ATTACHMENT B

Ref/Job No: 15NAR_3373

RE: Trail 12 Alternate Alignment Inspection – DA 6751 Stage 1B MTB - Thredbo Alpine Resort

Figure 1: Trail 12 alternate alignment.

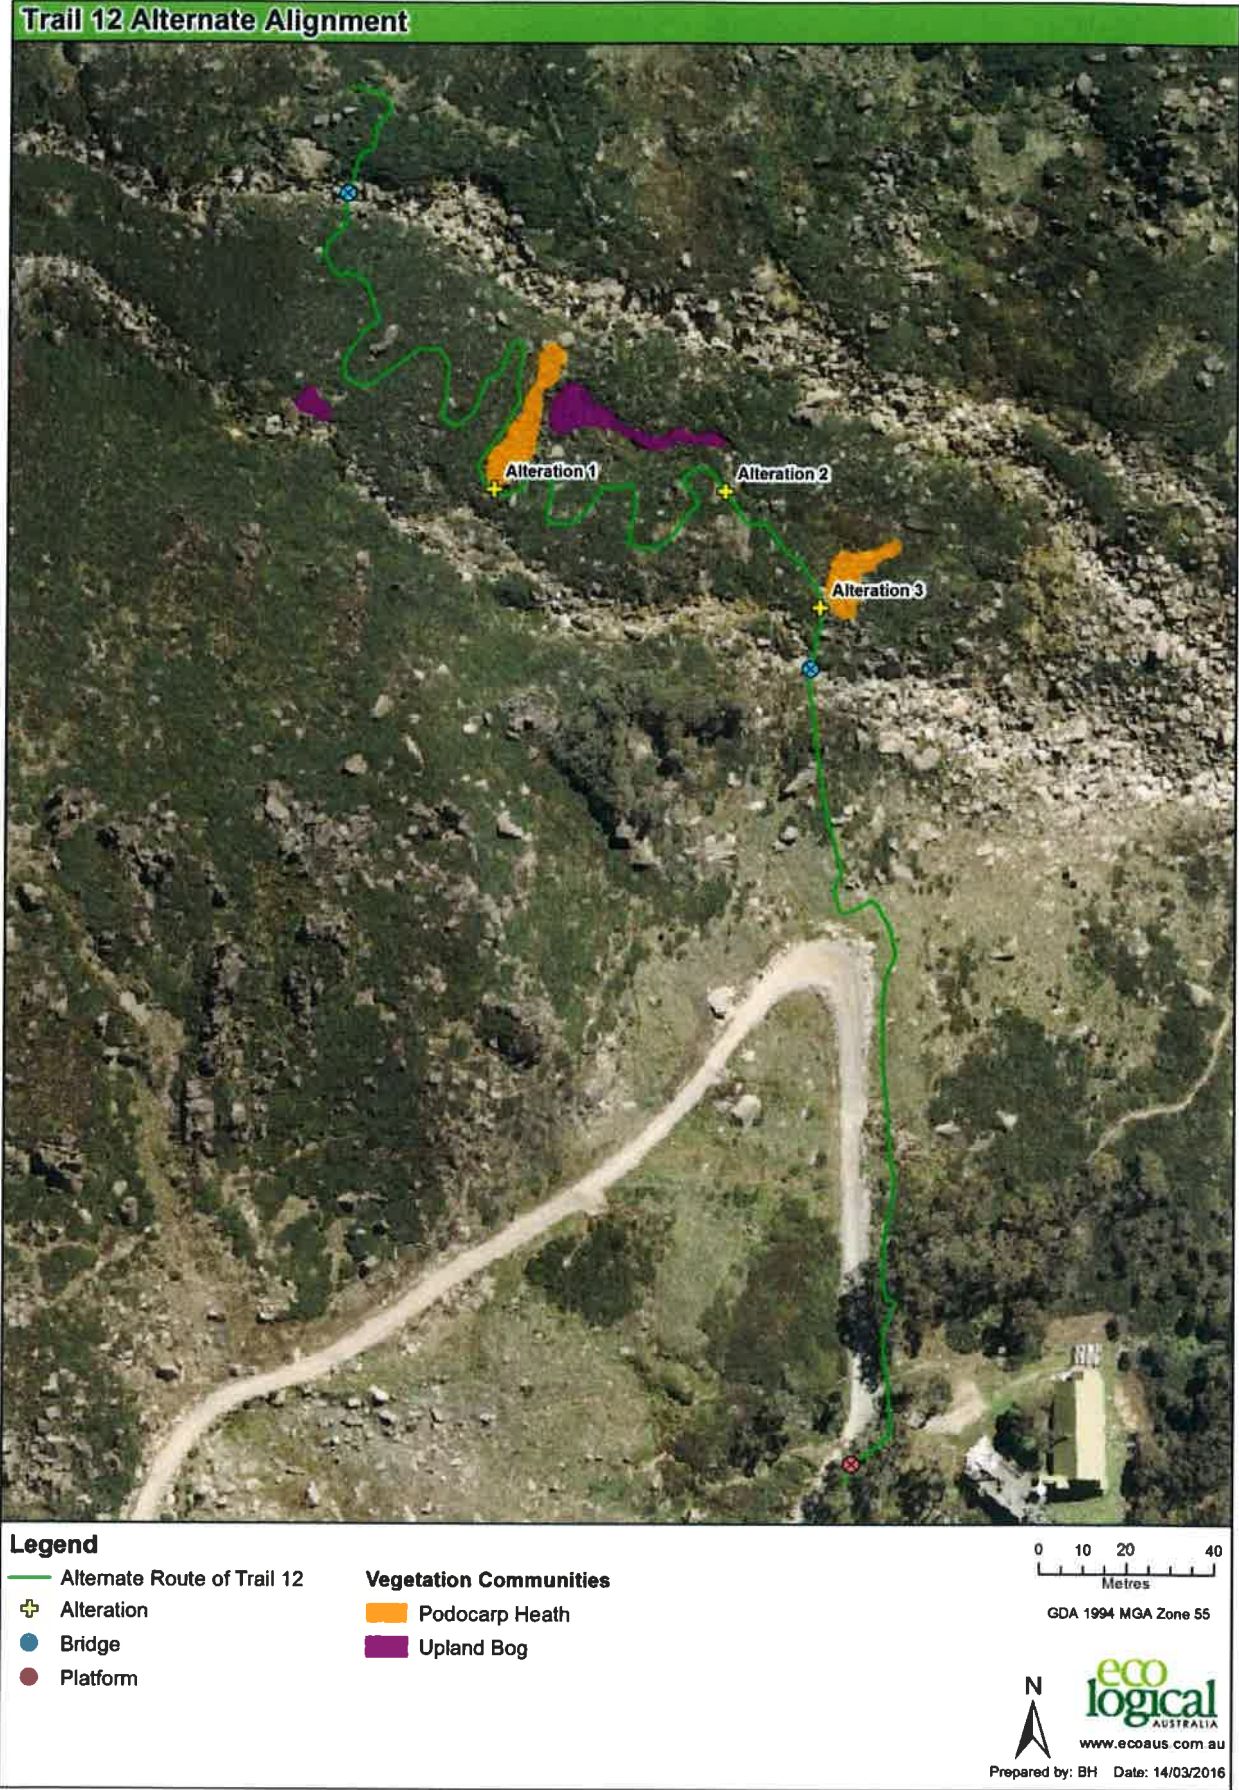
The alignment does not impact on any Upland Bog, although there are small areas of Upland Bog near the alignment in two locations, as shown in **Figure 1**. There are a couple of plants of *Richea continentis* where the alignment is in the batter to the Summer Road adjacent to the Snow Gums restaurant, as shown in **Photo 4**. These plants are not considered to be of any conservation significance given that the vegetation within the proposed alignment is highly disturbed in that area. The Summer Road traverses the toe of a patch of Upland Bog in this area, as shown in **Photo 5**, and the parts above the road remain in good condition. The Upland Bog does not extend significantly below the Summer Road and the *Richea continentis* plants below the road are restricted to the edge of the road batter. The proposed alignment, whilst it will result in the removal of a couple of *Richea continentis* plants, will have less impacts on vegetation and fauna habitats than any alternative through this area.

Whilst there are two small areas of Podocarp Heath immediately adjacent to the alignment, as shown in **Figure 1** and **Photo 6**, recommended minor modifications to the alignment will ensure that the alignment will not impact directly upon this community.

- It is recommended that the alignment be modified slightly so that the alignment does not affect the areas of Podocarp Heath, as shown in **Photo 7** and **Photo 8** and **Figure 1** (Alterations 1 and 3).
- It is recommended that the alignment be modified slightly so that the alignment does is further from a minor watercourse, as shown in **Photo 9** and **Figure 1** (Alteration 2).
